## PUSH ROD COVERS — 1200/1340 cc ENGINES

On April 5, 1979, Mailgram ML-744 was mailed to all dealers. The mailgram notified you of a possible oil or vacuum leak at the upper end of the front cylinder exhaust push rod cover on engines in the following crankcase number range:

Figure 1. Push Rod Assembly

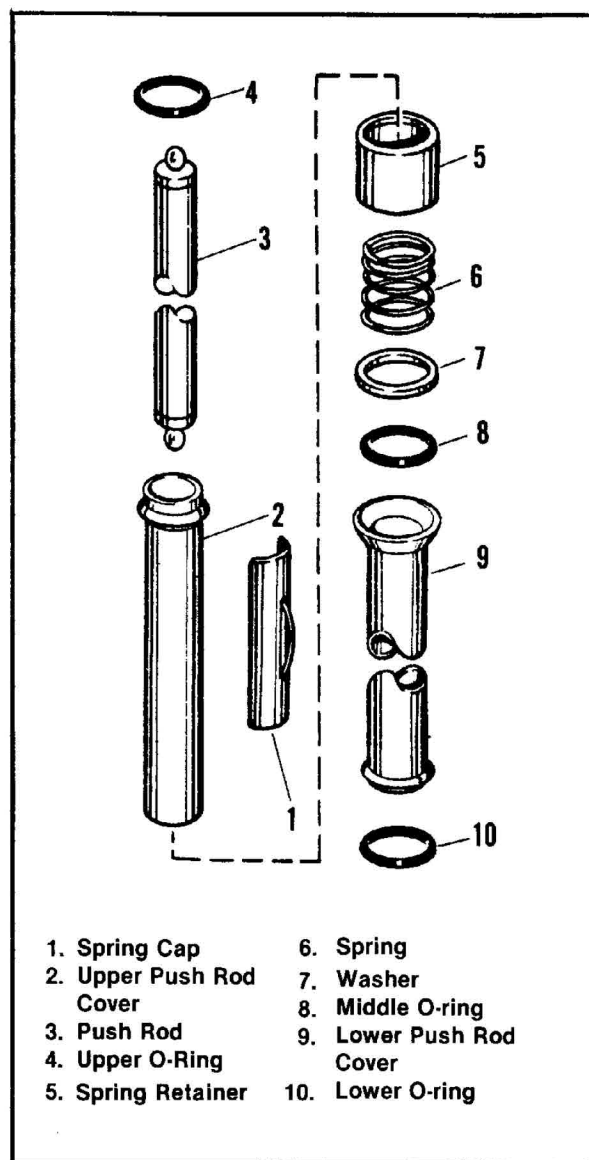
These engines used new style push rod covers and O-rings. The front cylinder exhaust push rod cover is too short and may cause the leak. To prevent this from occurring, replace this exhaust push rod cover with a lengthened push rod cover, part number 17935-79A. Use the following procedure.

If the new lengthened push rod cover is not readily available, old style push rod cover, part number 17935-66 may be used instead, providing a cork gasket, part number 17955-36 is substituted for the upper O-ring (4, Figure 1).

1. See Figure 1. Remove the spring cap (1) on the front cylinder exhaust push rod. Lift up the lower push rod cover (9) to expose the adjusting screw.
2. See Figure 2. Loosen the locknut (1) and bottom the adjusting screw (2). Remove the push rod assembly (3).
3. See Figure 1. Remove the upper push rod cover (2) from the push rod assembly.
4. Place a lengthened push rod cover, part number 17935-79A over the push rod and assemble items 2-10 as shown in Figure 1.
5. See Figure 2. With the tappet in its lowest position, turn the adjusting screw (2) upward, shortening the push rod, until push rod has a noticeable shake. Place a wrench on the flats at the base of the push rod to prevent it from turning. Slowly turn adjusting screw downward until all shake has been eliminated. Turn the adjusting

6. Install the spring cap (1, Figure 1).
